# Planning & Zoning Commission

May 30, 2017 Meeting

| <p><b>SUBJECT:</b> Consider recommending approval of PZ Case 17-21, the site plans for As We Grow Daycare at 10015 NW 61<sup>st</sup> Avenue.</p> |  |

Job No. 17035  
Proj. Mgr. SP  
Sheet Title  
**EXTERIOR ELEVATIONS**  
Sheet No.

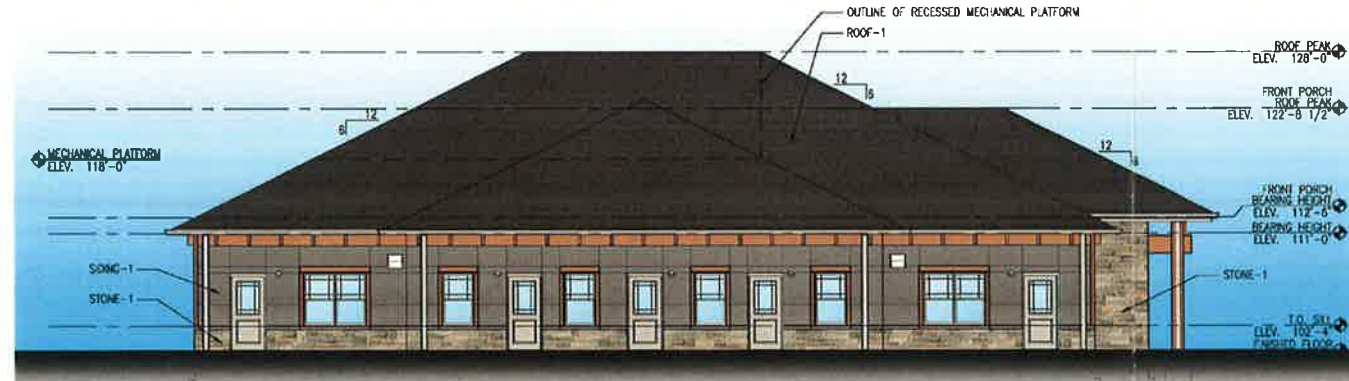
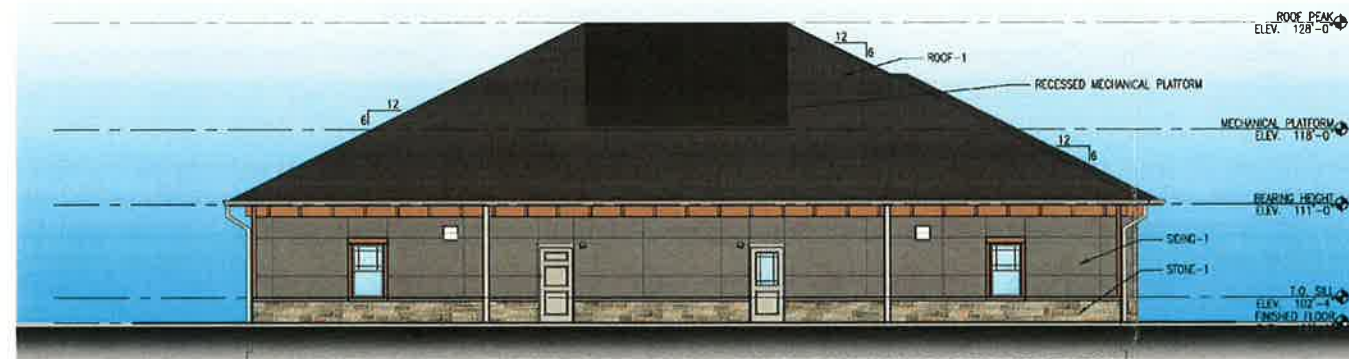
Chapter 166.35.2.C of the Code of Ordinances states structures within commercial districts shall consist of a combination of brick, architectural concrete panels, textured concrete block, or architectural steel, or stone panels over 75% of the wall area on all four building sides (excluding glass).

Proposed architectural materials include fibercement panels, and stone to meet the above-listed requirements in the following percentages:

East Elevation (front)

- 30% Hardi Panel (281 s.f./950 s.f.)
- 48% Stone (460 s.f./950 s.f.)
- 8% Hardi trim (73 s.f./950 s.f.)

South Elevation

- 40% Hardi Panel (390 s.f./975 s.f.)
- 22% Stone (217 s.f./975 s.f.)
- 13% Hardi trim (125 s.f./975 s.f.)

North Elevation

- 45% Hardi Panel (438 s.f./975 s.f.)
- 23% Stone (225 s.f./975 s.f.)
- 13% Hardi trim (124 s.f./975 s.f.)

West Elevation

- 60% Hardi Panel (546 s.f./898 s.f.)
- 20% Stone (177 s.f./898 s.f.)
- 11% Hardi trim (96 s.f./898 s.f.)
